Enclosed is the response to your Notice of Deficiency for Operable Unit 1085.

**List of Deficiencies
Los Alamos National Laboratory
Operable Unit 1085**

Response to NOD for RFI Work Plan for OU 1085

Figure 5-2. Sampling locations in the eastern portion of Aggregate 1—TA-12: Inactive Firing Sites. The steel pit [12-001(a)] and open pit [(12-001(b)] represent the center of the firing sites.

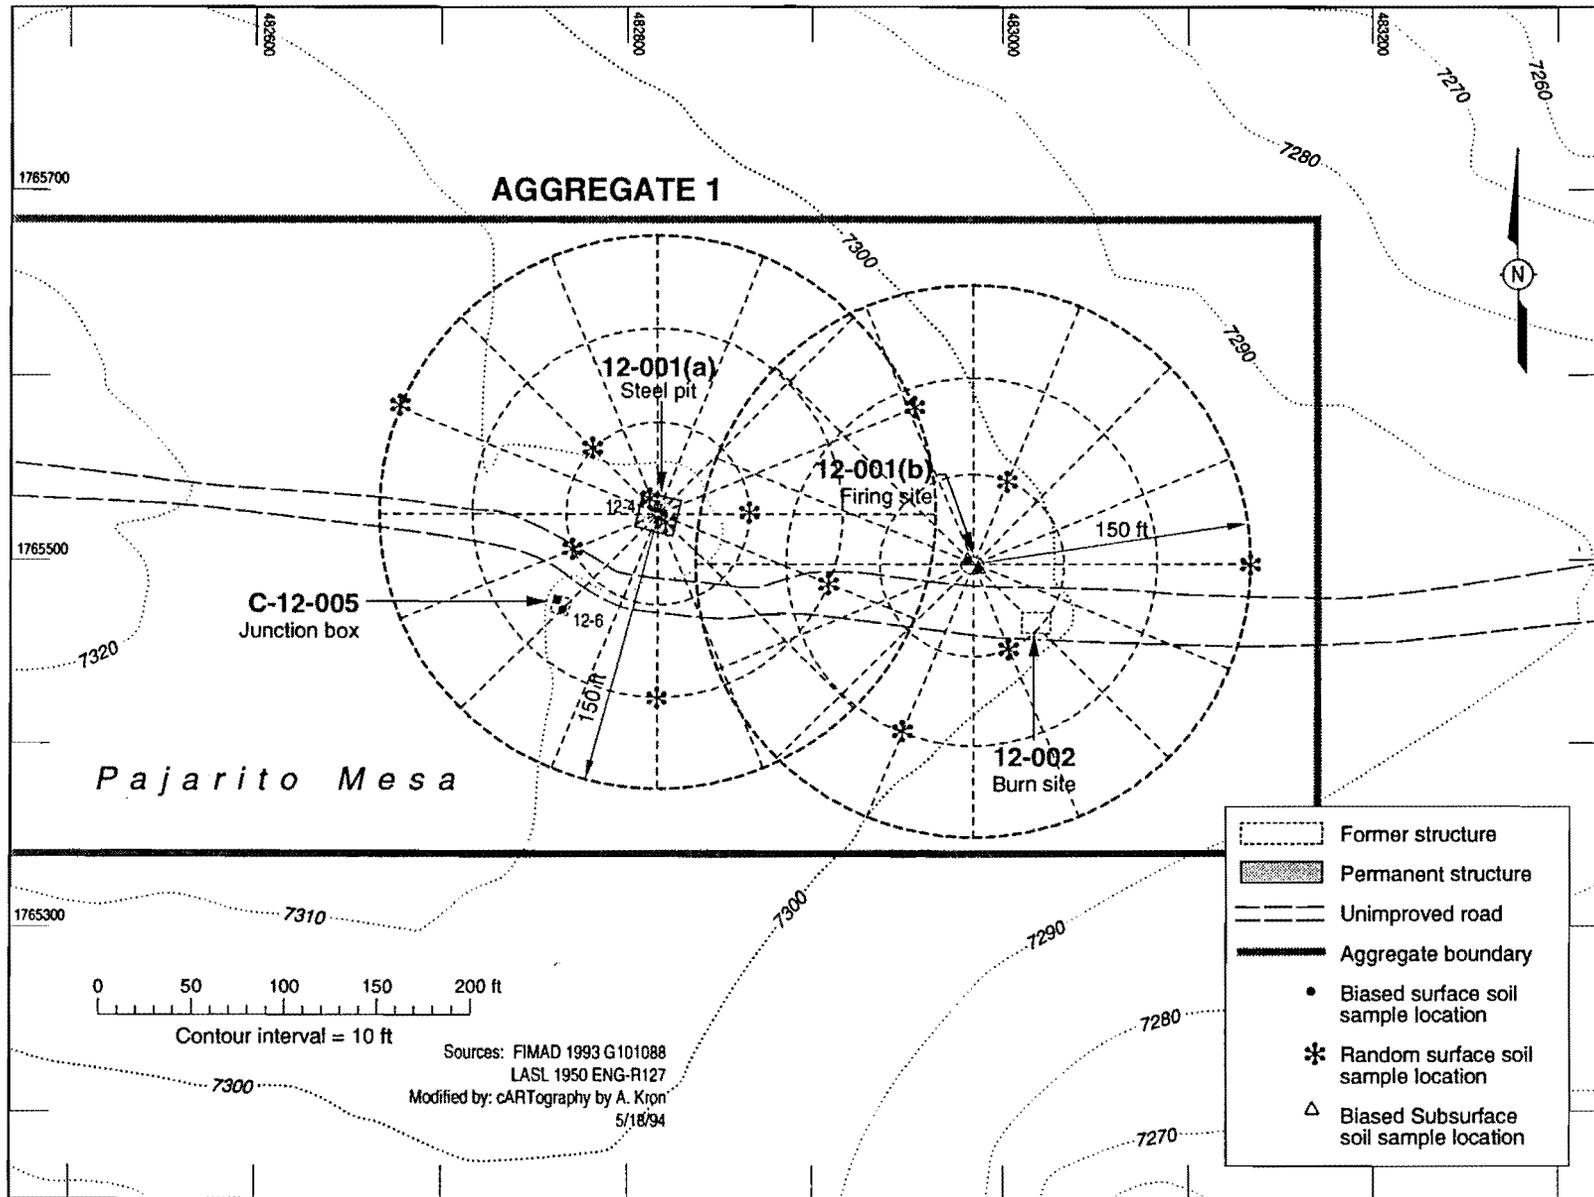
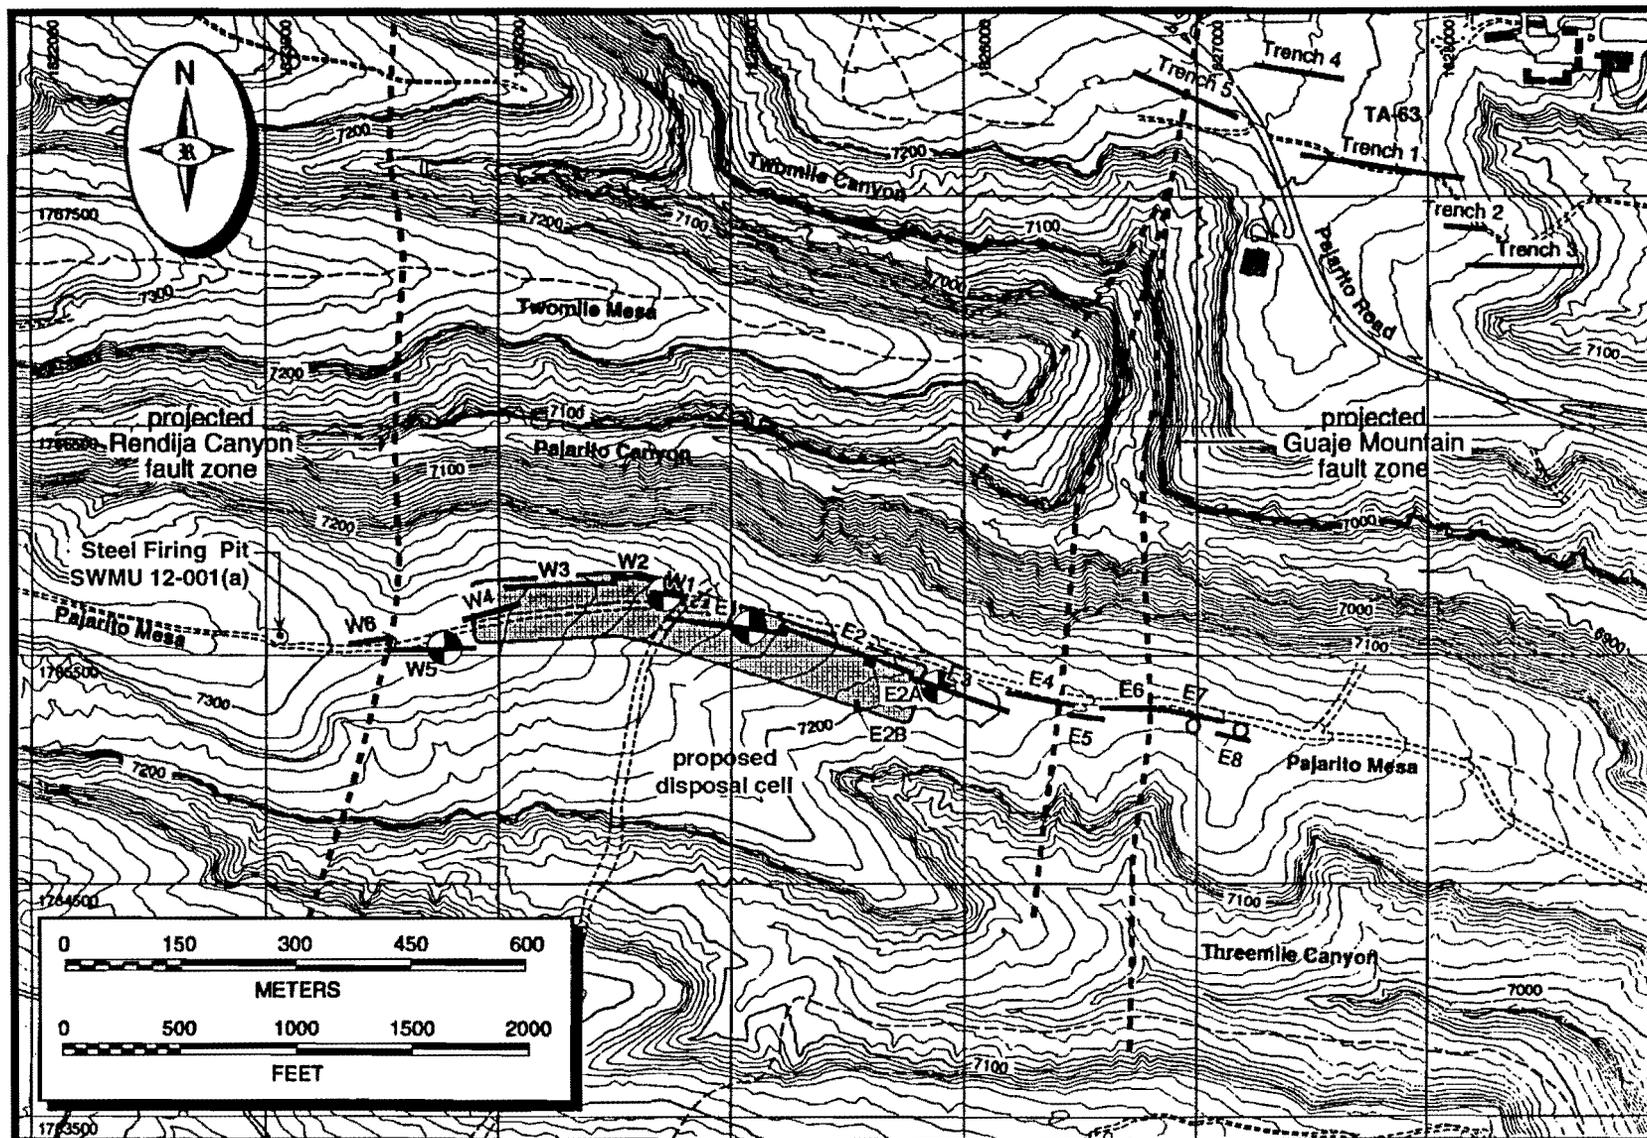
1. Section 5.1 - A more detailed VCA plan should be submitted separately for unit 12-001(b) to EPA for approval as this will be considered the final remedy for this unit. Will removing the visible HE from the surface be sufficient to address the actual pit where HE was detonated? EPA is concerned that there may be residual HE in the pit. Is the VCA to be based on the five samples to be collected (p. 5-1-12 bottom)? Text is not clear on the use of the five samples.

4. Section 5.1.6 Phase I Sampling and Analysis Plan, p. 5-1-13 - There is no description of the grid proposed in the field screening section. This information along with a figure showing the grid should also be provided. In addition, how can you determine what two times background is until background sampling has been conducted for this area. Locations of background samples should be included in the figures.

Response: LANL agrees that removing the visible HE from the surface may not be sufficient for a VCA of PRS 12-001(b). The visible HE is required to be removed as part of the initial site survey by DX-16 (Explosives Development Group) personnel as a safety precaution. Since both sites [12-001(a) inside the pit] are known to have both HE and uranium contamination, LANL thus proposes to characterize both 12-001(a) and 12-001(b) for a baseline risk assessment by collecting samples from randomized locations. This baseline risk assessment will be conducted after removal of surface HE by explosive safety personnel during a field HE survey. In the baseline risk assessment, two samples each will be collected within the centers of each of the firing pits and from a polar sampling grid centered on each pit. The 150 ft. sampling radii of the two SWMUs overlap in the area between the sites; thus sampling will be collected within three regions of the polar grids: 1)

The area unique to 12-001(a); 2) The area unique to 12-001(b); and 3) The area common to both (see revised Figure 5-2, attached).

A total of 11 samples will be collected from the areas immediately surrounding the firing sites. Three samples will be collected within the area common to both grids, and the unique portion of the grids will be sampled at eight random points: two samples at each of the 50 ft distances, and one sample at each of the 100 ft and 150 ft distances. Upon completion of the baseline risk assessment sampling, LANL will determine the need for a VCA and submit such plans, if a VCA is required, according to EPA and NMED policy.

Response: The grids for 12-001(a) and 12-001(b) are polar grids, extending 150 feet from the center of the firing pits at 50 foot intervals, with intersecting radial lines at due North and 22.5° intervals (see revised Figure 5-2) around the circumference. Random samples will be taken at eleven locations on the two grids, with three samples taken in the area where the two grids overlap, and four points each in the areas where the two grids do not. Background levels in the area will be determined from 140 soil samples that have been taken on Threemile and Pajarito mesas as part of the LANL framework studies. The attached figure (located immediately after the map and sampling and analysis plan for Aggregate 1) indicates the locations of background samples relative to SWMU 12-001(a). Analytical data on these samples is expected to be returned in FY95.

Figure 5-7. Sampling locations in Aggregate 3—TA-14: Western Area.

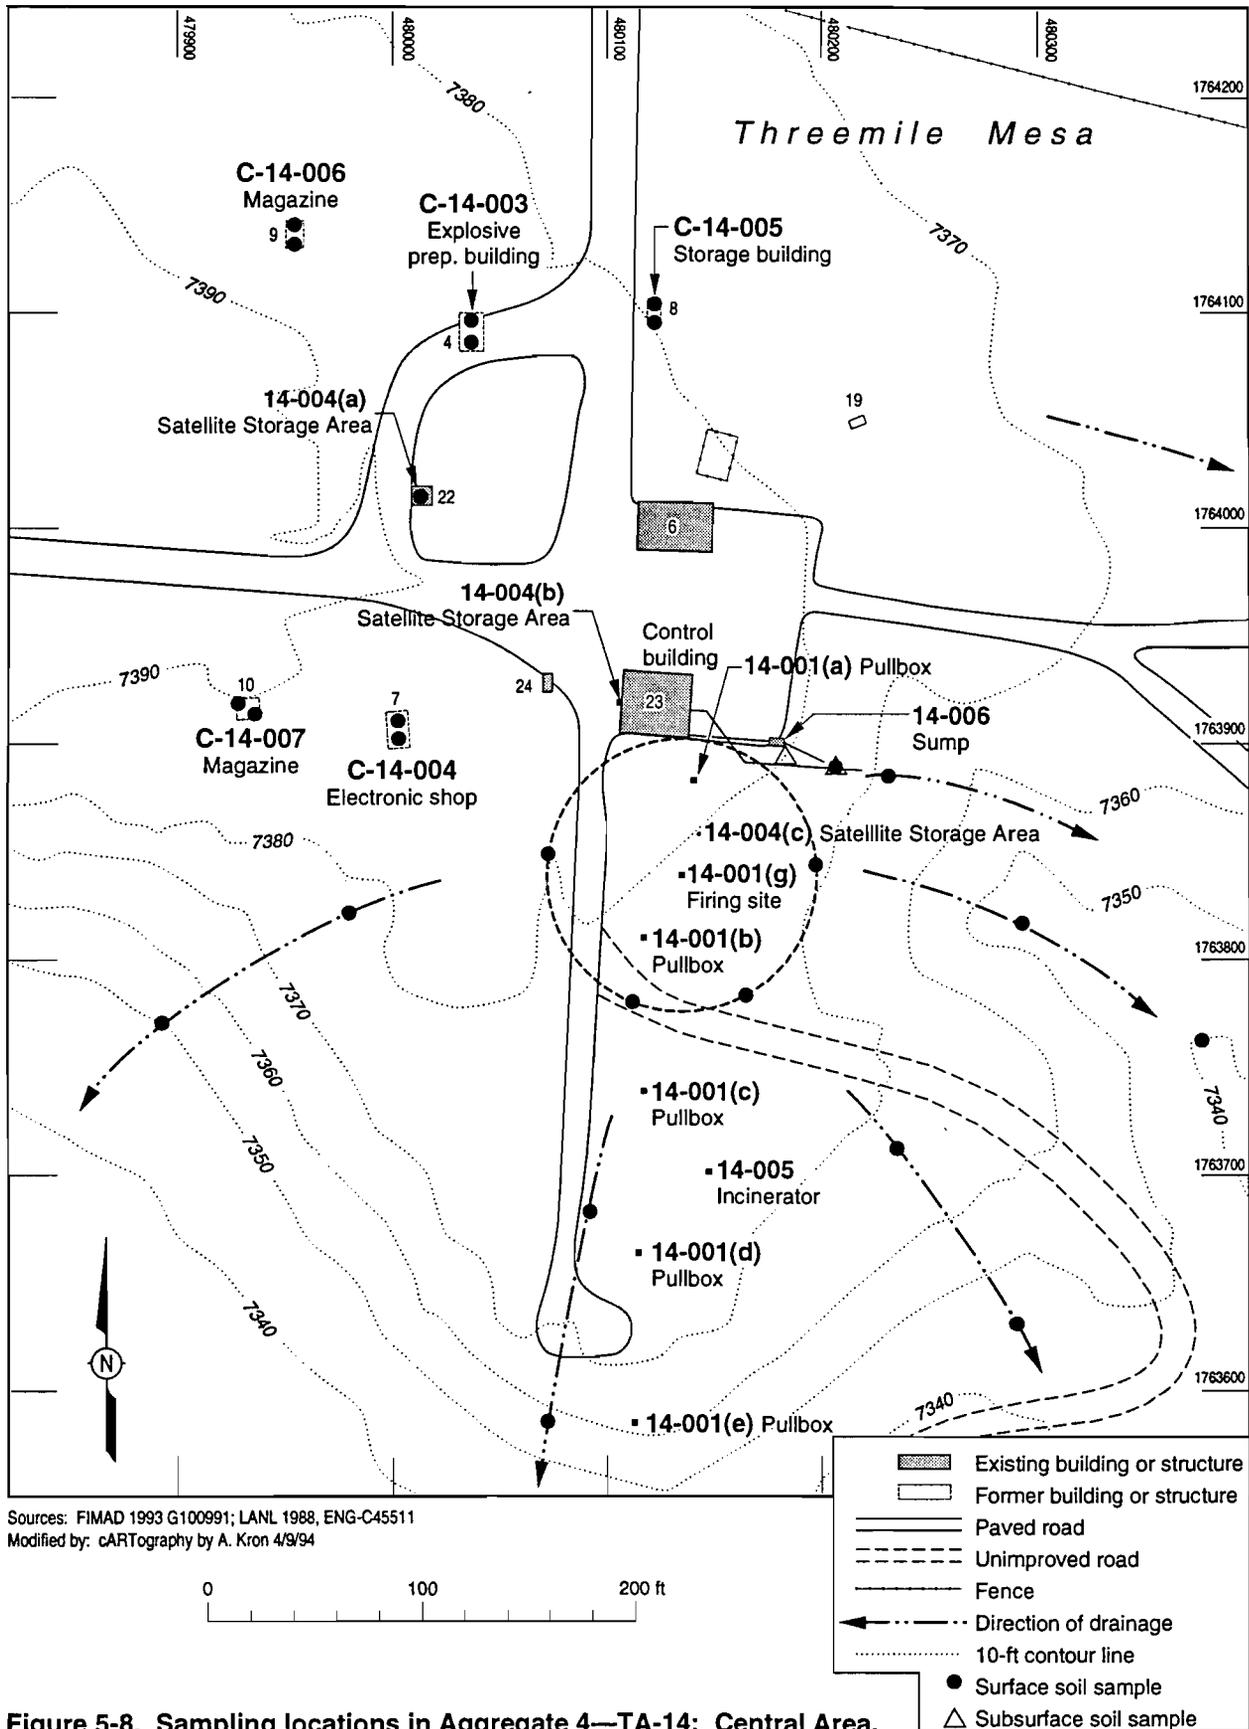
- b. **LANL needs to provide more information concerning the selection of sampling locations for the eight surface samples. A detailed drawing of the drainage paths would be helpful.**

Response: Releases from the site along the drainage channels are addressed in the sampling plan (section 5.3.6.2.3; see revised Figure 5-7). Samples in the drainage channels will be taken at approximately 50, 100, 150, and 200 ft downgradient from the mesa top, and biased towards sediment catchments where higher concentrations of contaminants are likely to be found.

Figure 5-8. Sampling locations in Aggregate 4—TA-14: Central Area.

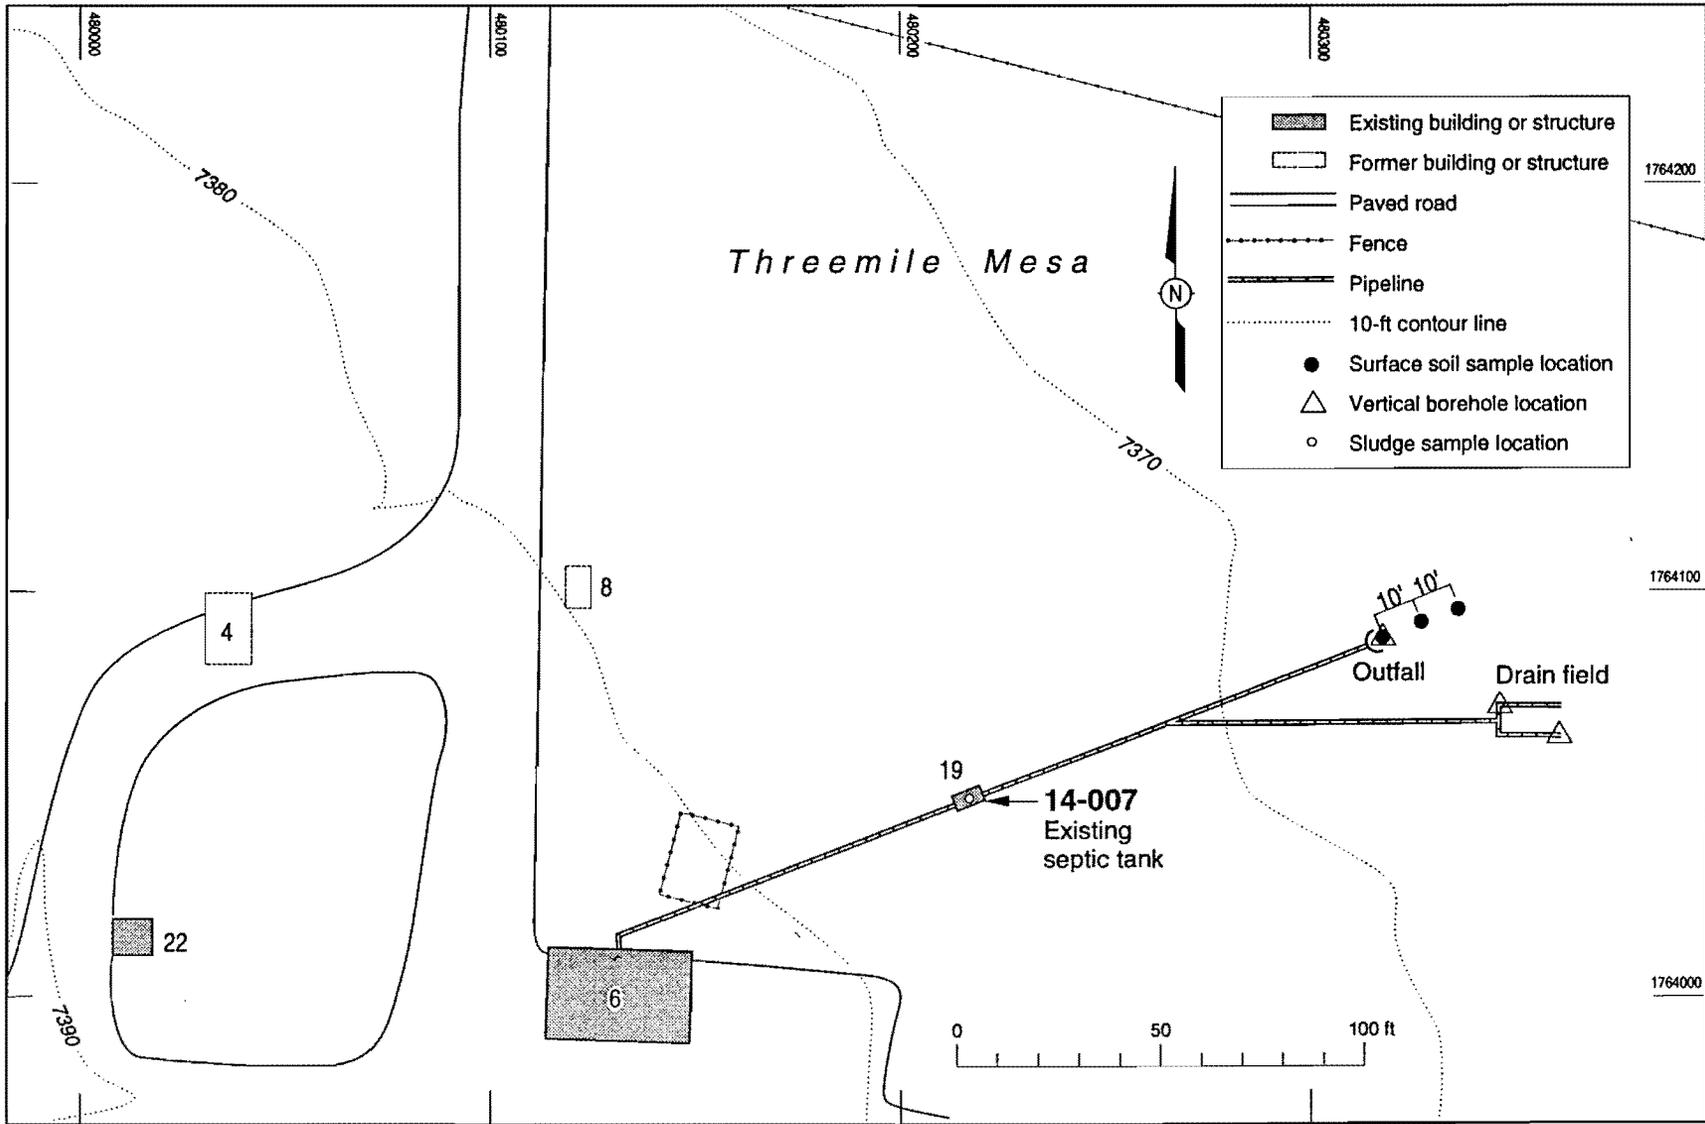
10. **SWMU 14-006, p. 5.4-3 - LANL shall sample the outfall area of this SWMU. Samples should be collected at 6 inches and 18 - 24 inches in depth next to the outfall (even into the tuff). LANL shall provide a figure which indicates the sampling locations and the unit in more detail. Has the sump been or can it be examined for leakage?**

Response: LANL will sample the outfall area of the sump, including surface (0–6”) and subsurface (18–24”) soil samples at the site of the outfall and at 25’ downgradient (0–6” depth) in the drainage channel (see revised Figure 5-8). The sump consists of a welded aluminum tank—constructed of 1/4” thick plate—grouted into an existing concrete sump (engineering drwg. ENG-C-30415); the sump may be visually examined from ground level by opening a hatch at the surface. LANL will physically examine the sump for leaks and sample adjacent to the sump with a shallow borehole (5–8’) to analyze for HEs, metals, and uranium.
